DESIGN REVIEW COMMITTEE

April 17, 2024 6:00 PM

5.I. 3538 South Fulton Avenue Solarium

DEPARTMENT OF PLANNING AND ZONING
PLANNER'S REPORT

A-1

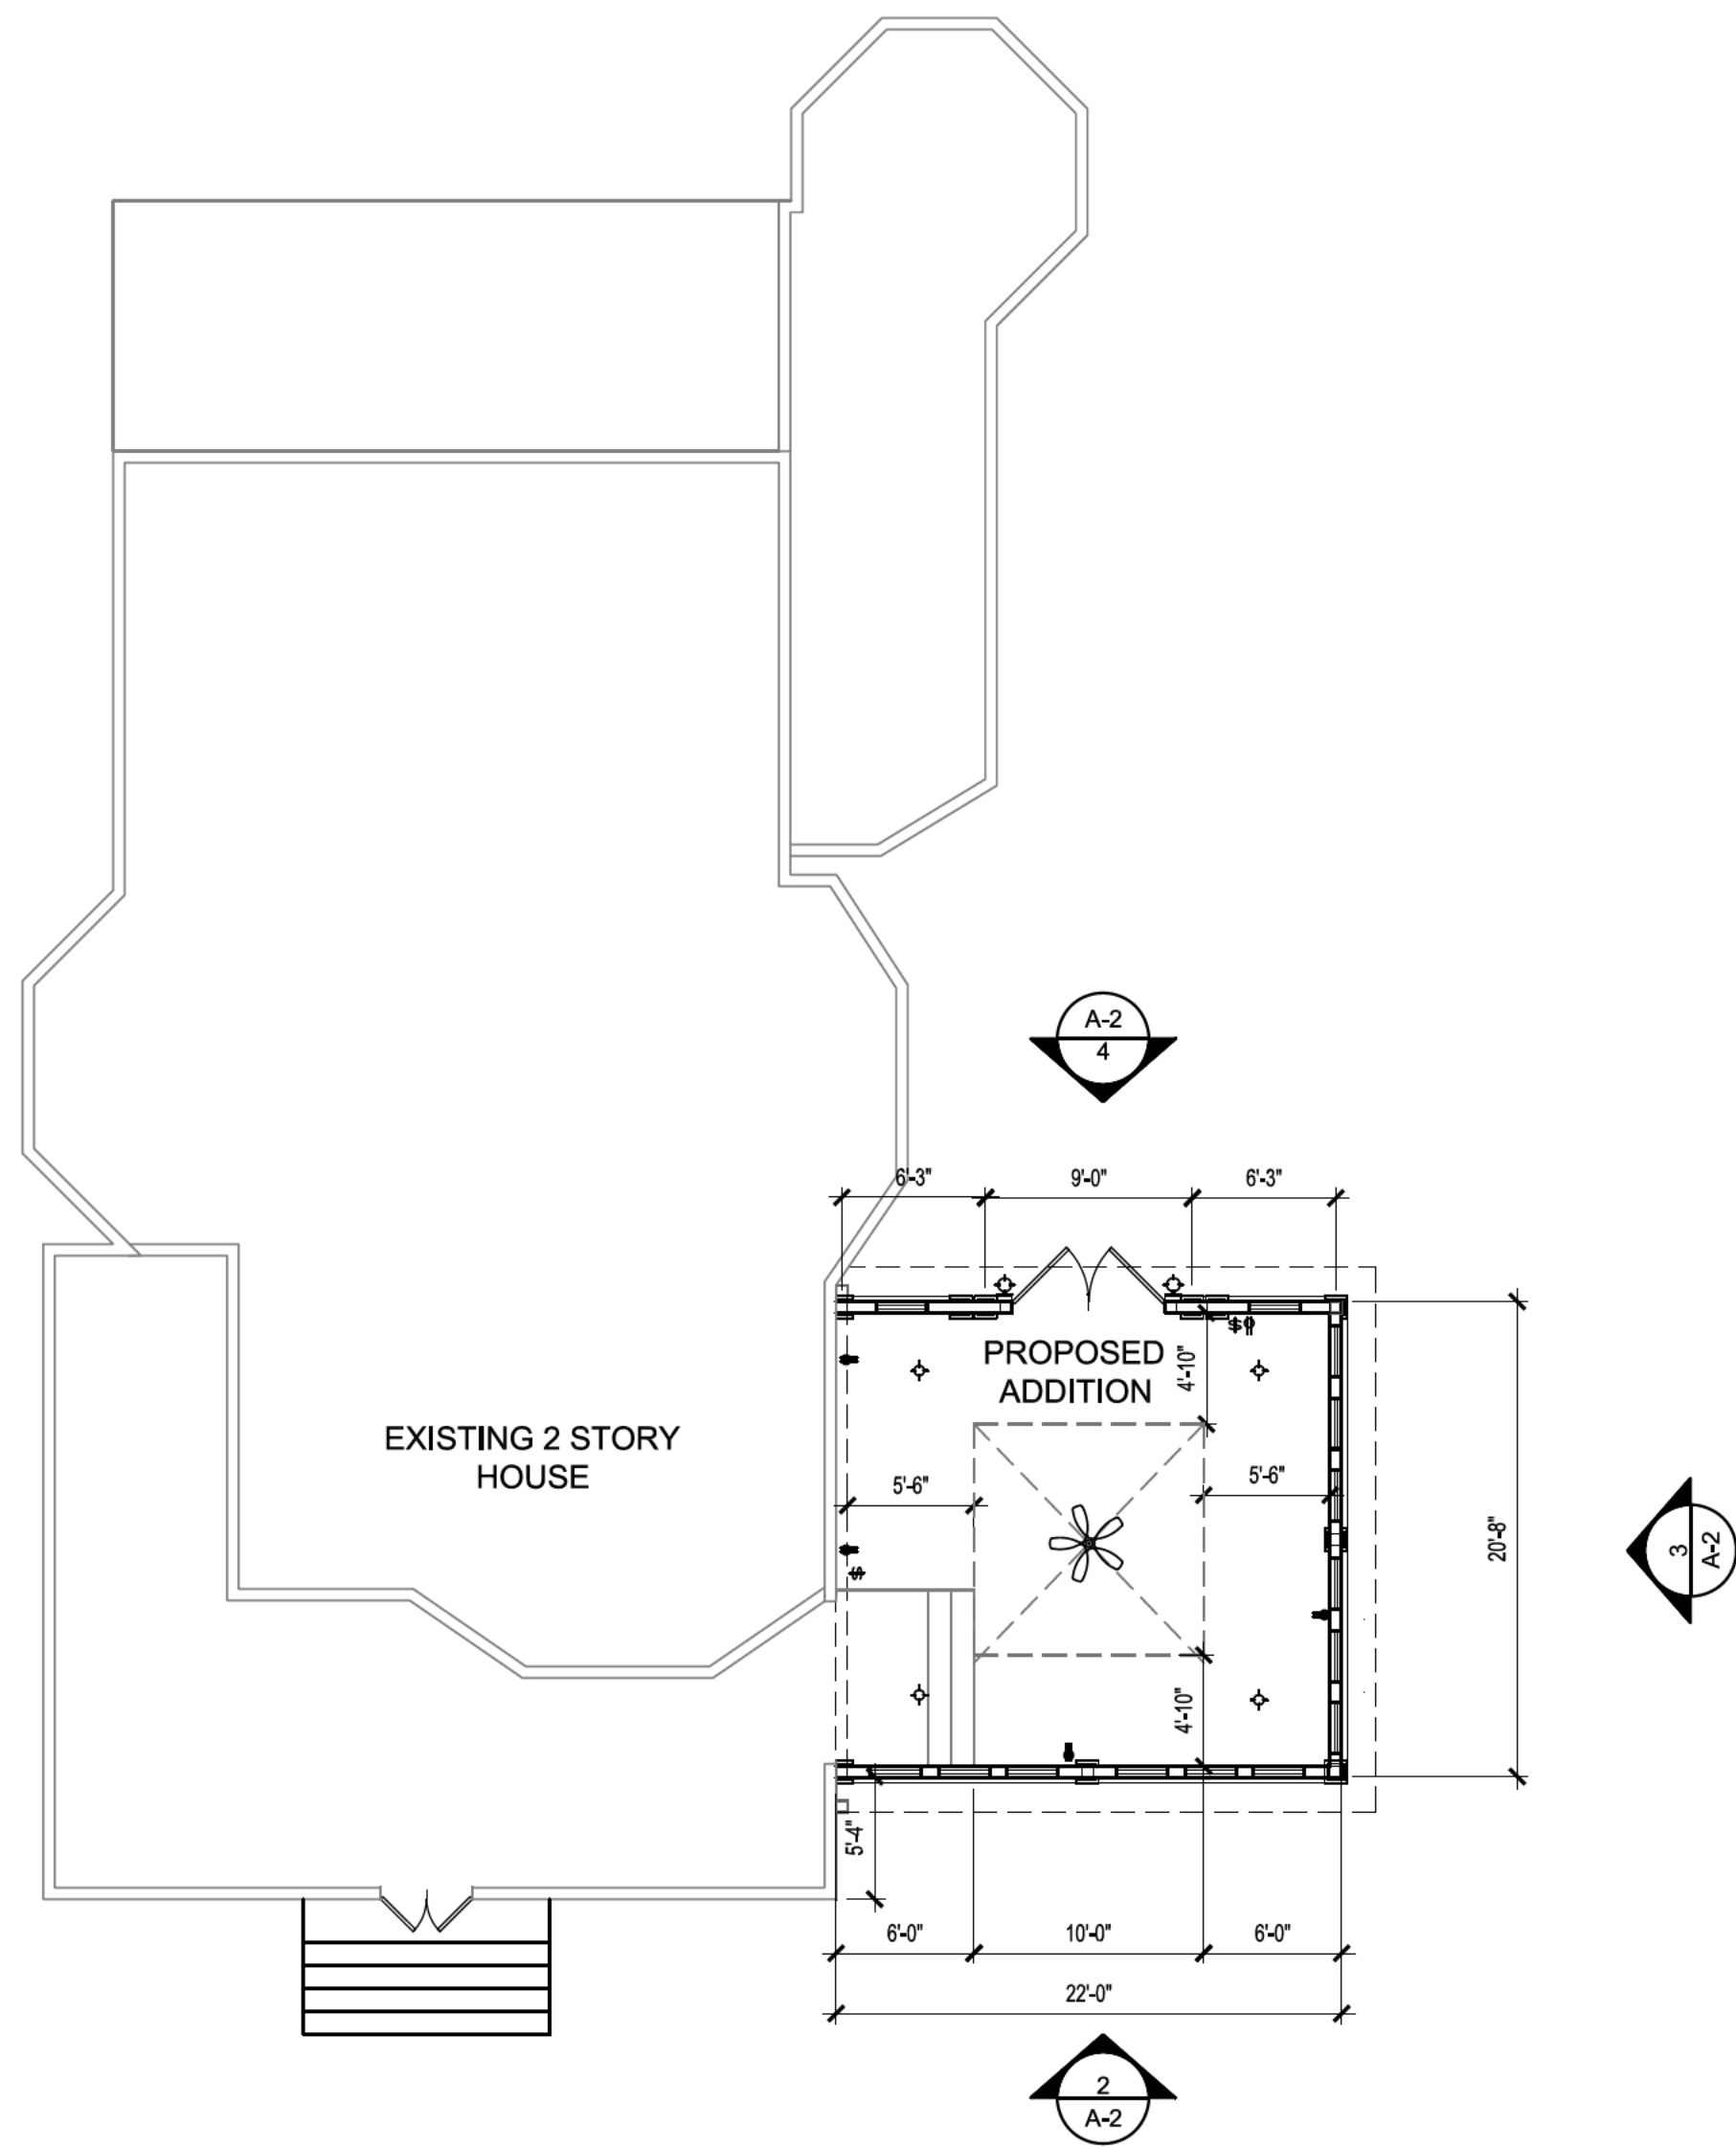
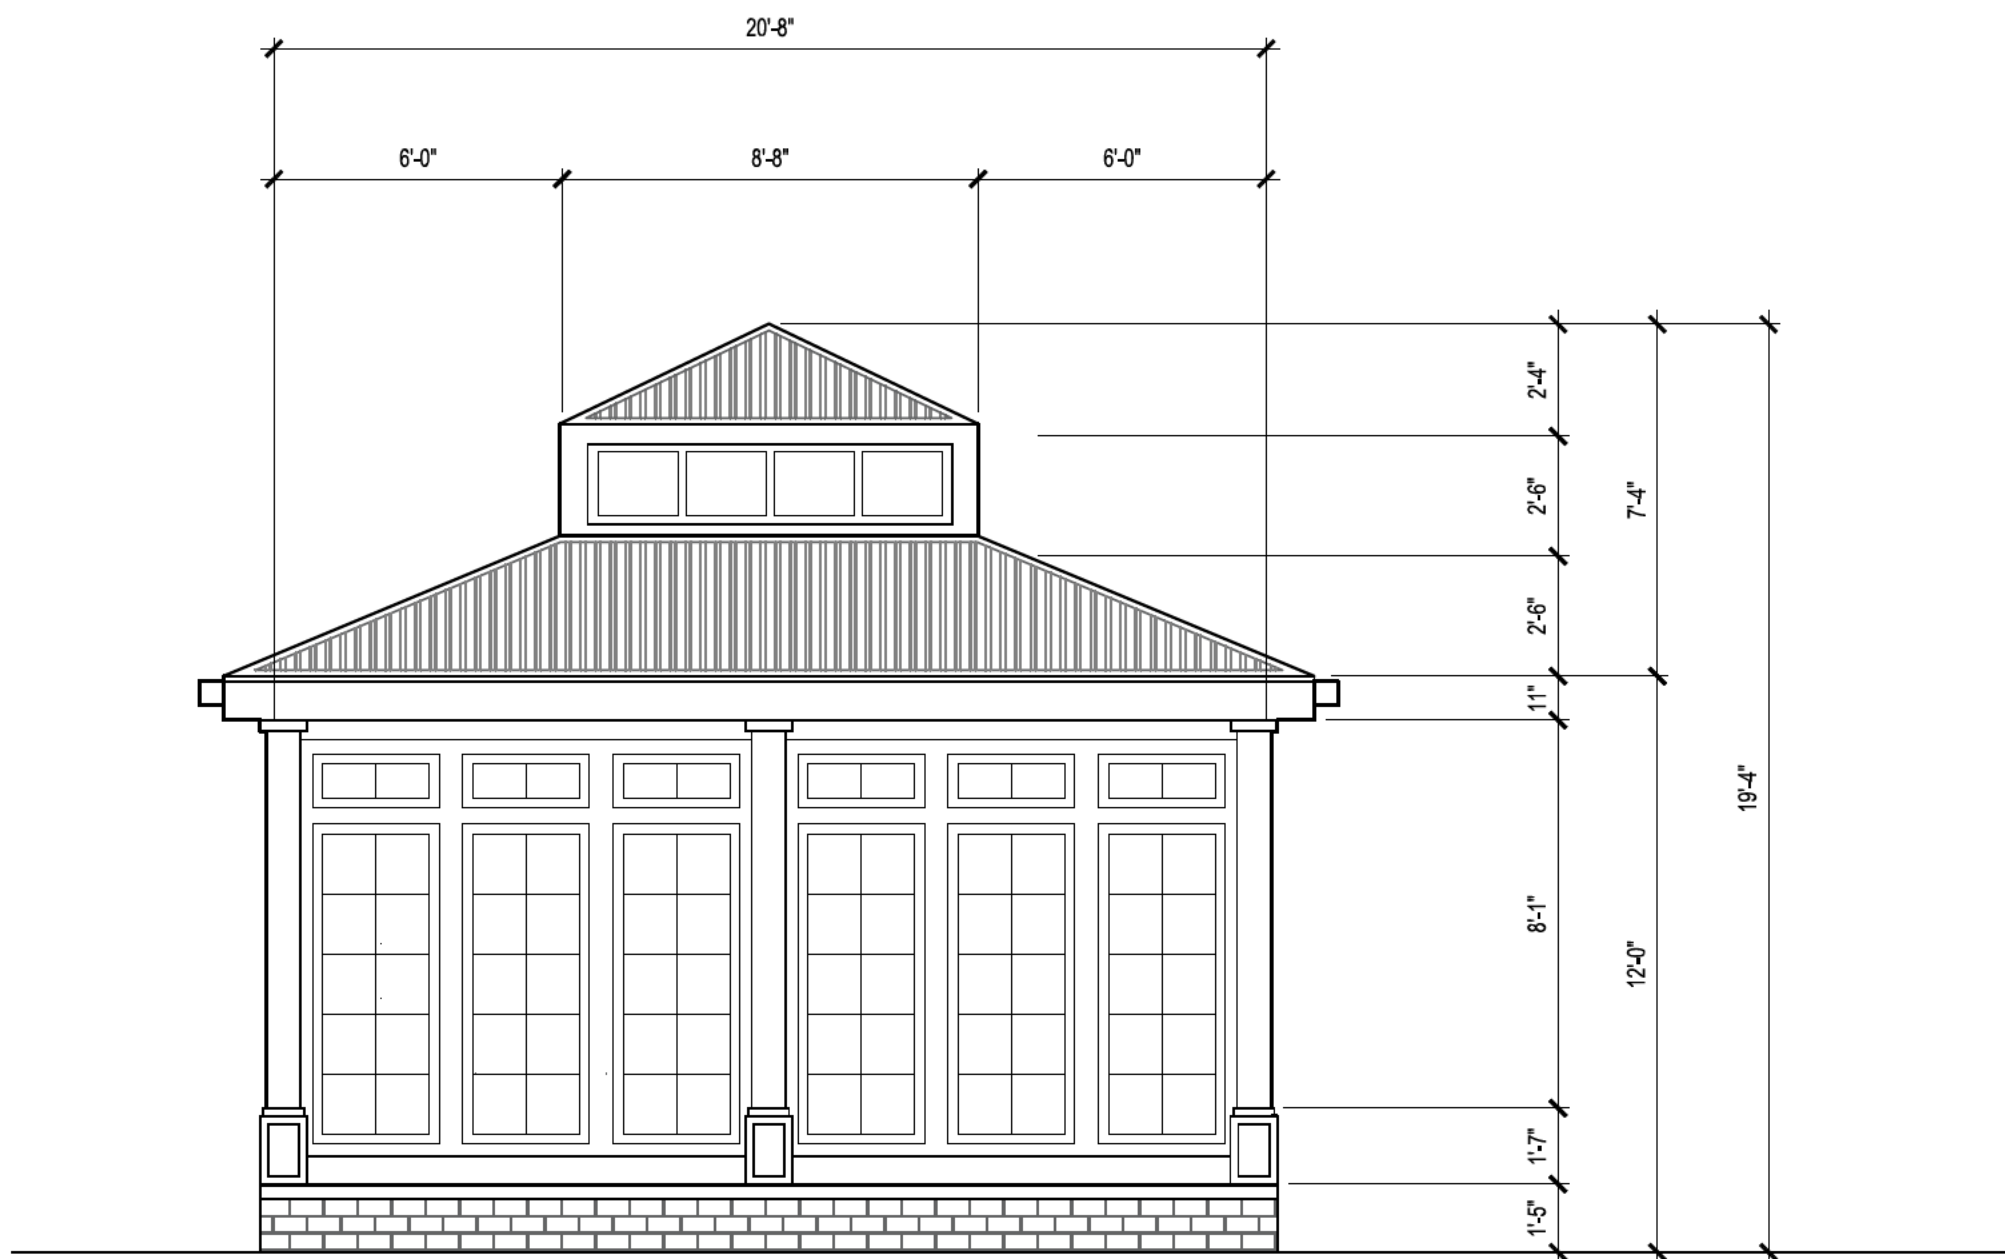
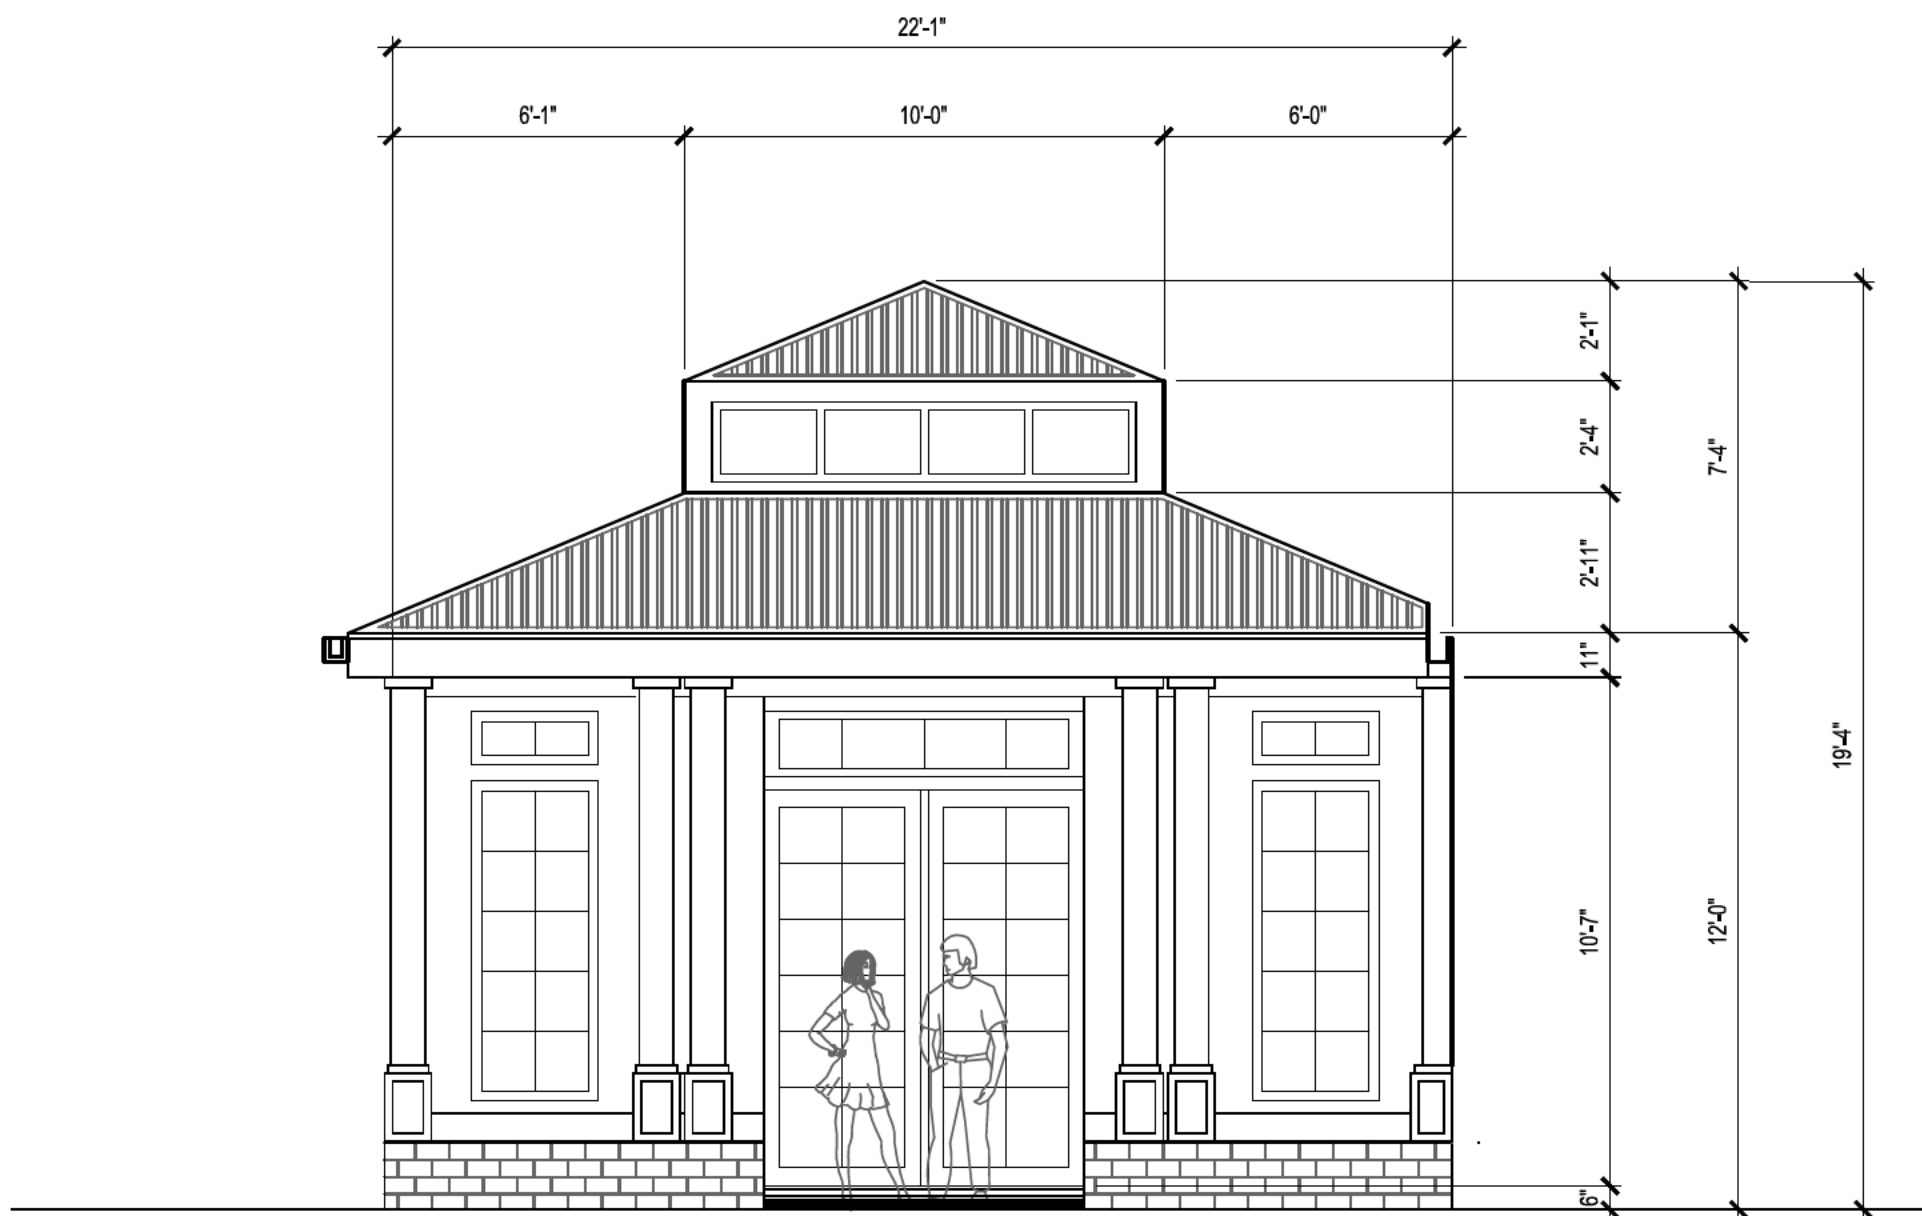
The site plan indicates 424 SF, and the application lists 454 SF. Please correct.

STAFF COMMENT: Please provide warranty for roof. Downspouts and gutters not specified for material. DRC should review roof form.

STAFF COMMENT: Window detail and trim detail has not been provided per above standard.

- **Warranty for roof**
- **Materials for downspouts and gutters**
- **Detail for window trim per above requirements.**
- **DRC should review roof form**
